HORIZON®. HRZ-D MANUAL
ADDENDUM
June 1980

ADDENDUM to: HRZ-D MANUAL, REVISION_1

JUNE 4, 1980

HORIZON CHASSIS/MOTHERBOARD MB-4		SHT
POWER SUPPLIES		5 of 5
© 1977, NORTH STAR COMPUTERS, INC.

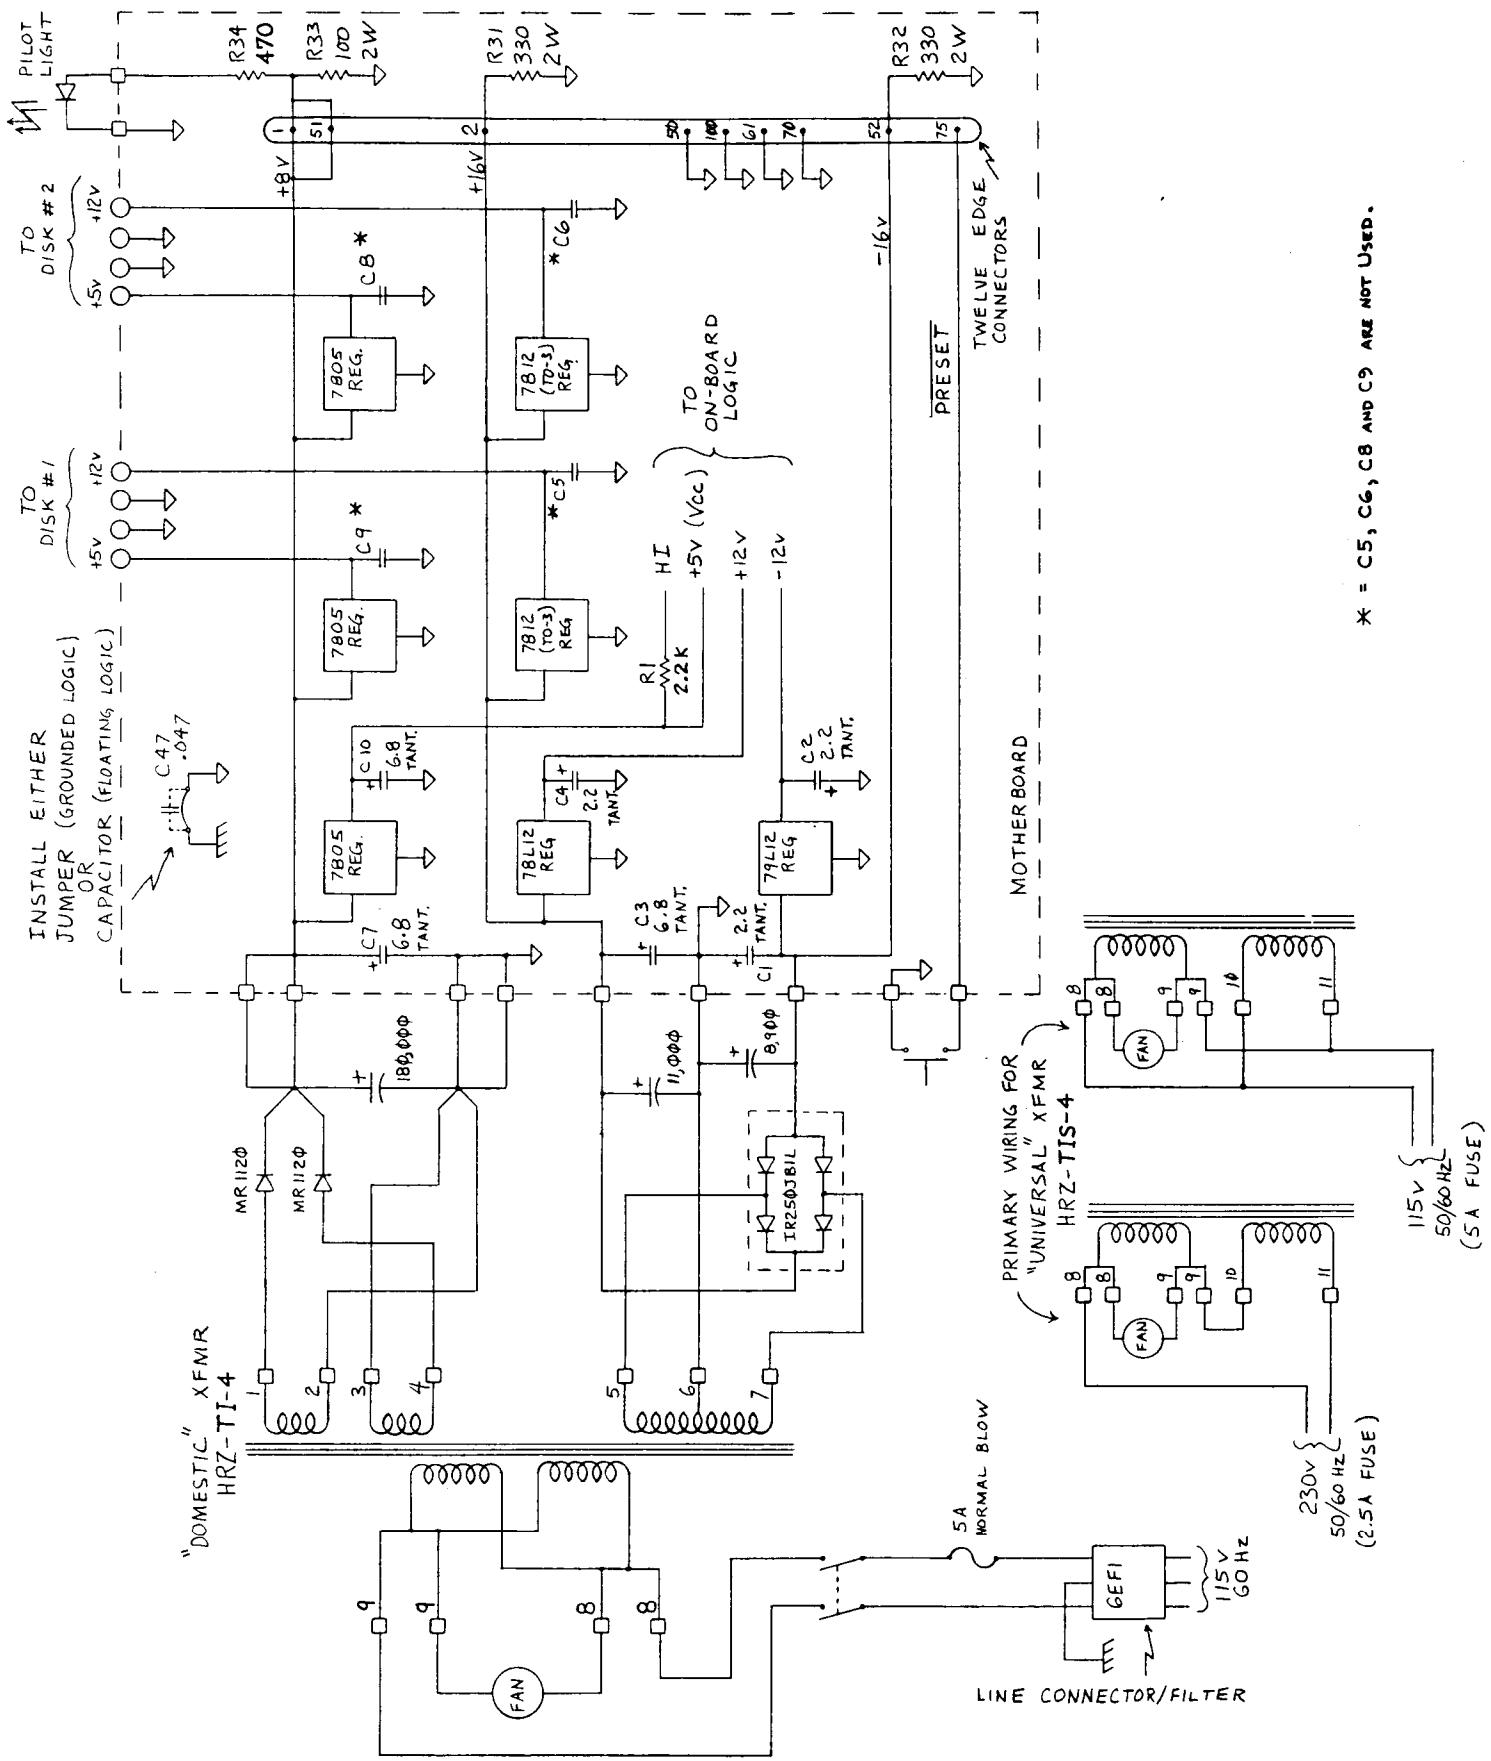
* = C5, C6, C8 AND C9 ARE NOT USED.
